66311B-09

S E R V I C E N O T E

**66311B - Mobile Communication DC Source,
15VDC/3A. GPIB, RS-232**

**Power-On Self test Errors, Auto reboot, Blank display. No output Communication errors.
No communication when using the GPIB Interface.**

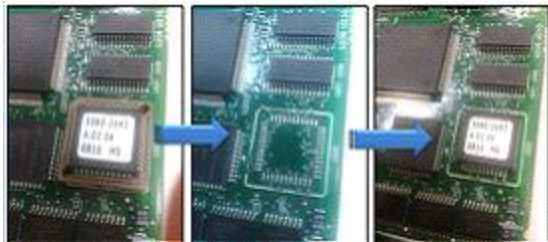
1. This problem can be solved by replacing the GPIB Interface assembly. See above for the tested interface P/N that is required to repair the instrument. The correct tested assembly for the specific model must be used when repairing a defective instrument.
2. This problem can also be solved by removing the socket (circuit reference U205) on the “A2” interface assembly and soldering the **Original** EEPROM directly to the Printed Circuit assembly.

It has been determined when removing the socket and soldering the EEPROM (circuit reference U205) directly on the interface assembly “A2” would be very difficult (See Picture below), even having the correct tools, removal of the socket and replacement of the EEPROM is very difficult and may cause additional quality and reliability issues.
